BONNET CARRÉ SPILLWAY STRUCTURE

PERIODIC INSPECTION REPORT NO. 7

CEMRC-ET-EG (CEMVN-ED-G/26 January 01) (11-2-240a) 3rd End
Stagg/ts/5644
SUBJECT: Mississippi River and Tributaries, Bonnet Carre
Spillway Structure, Periodic Inspection Report No. 7, 9
September 1999

SUBJECT: Mississippi River and Tributaries, Bonnet Carré Spillway Structure, Periodic Inspection Report No. 7, 9 September 1999

↑ PHOTO NO. 1 - A SIGNIFICANT SPALL WITH DEBRIS WAS NOTED ON THE WEST SIDE OF PIER 290-291 JUST ABOVE THE WEIR.

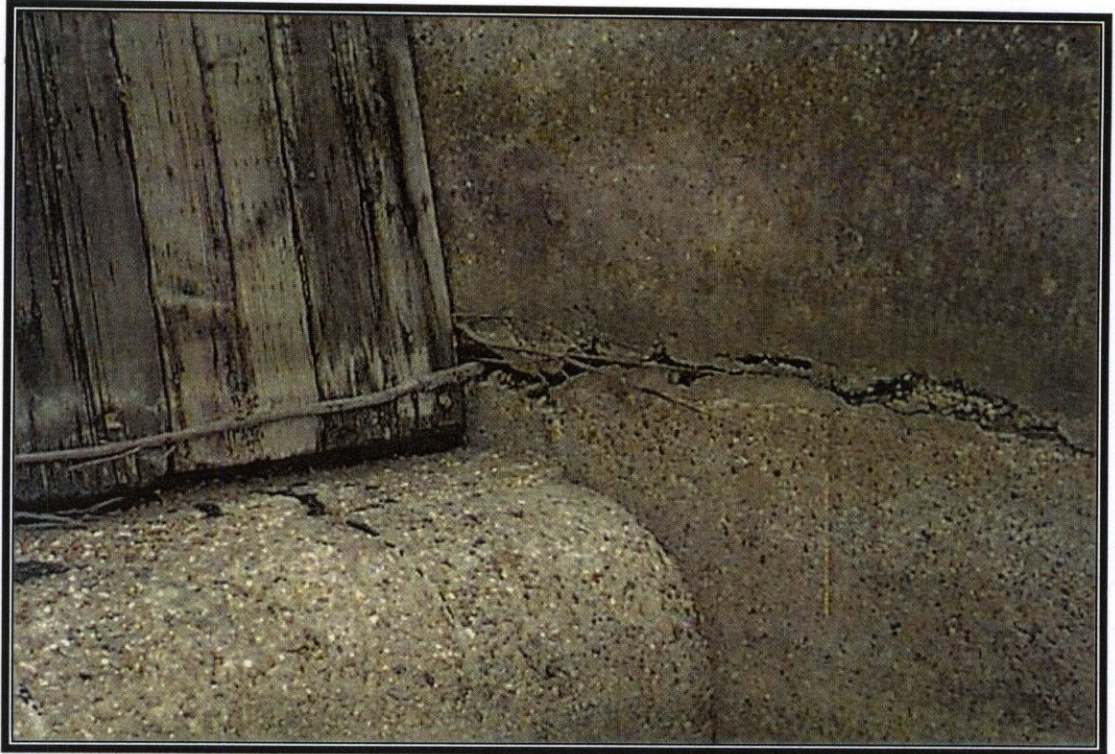
f. Paragraph 5-03b(1) page V-2. This paragraph states "horizontal cracks were noted in several piers (riverside)". The "spall" identified in Photo No. 1 is actually one of the horizontal cracks at the construction joints mentioned in this paragraph and is the subject of a recommendation in paragraph 6-02b(3). This crack is apparently not deep enough to expose rebars as there are no rust discolorations on the pier. However, cracks such as the large crack in pier 290-291 should be sealed in the near future to help deter corrosion of the rebars.

1f. Paragraph 5-03b(1). Concur. Paragraph 6-02b(3) has been revised as follows: The spall on the west side of pier 290-291 should be sealed to deter corrosion of the rebars. Monitor the other spalls on the structure and report changes to Engineering Division.

* (3) The spall on the west side of pier 290-291 should be sealed to deter corrosion of the rebars. Monitor the other spalls on the structure and report changes to Engineering Division. *
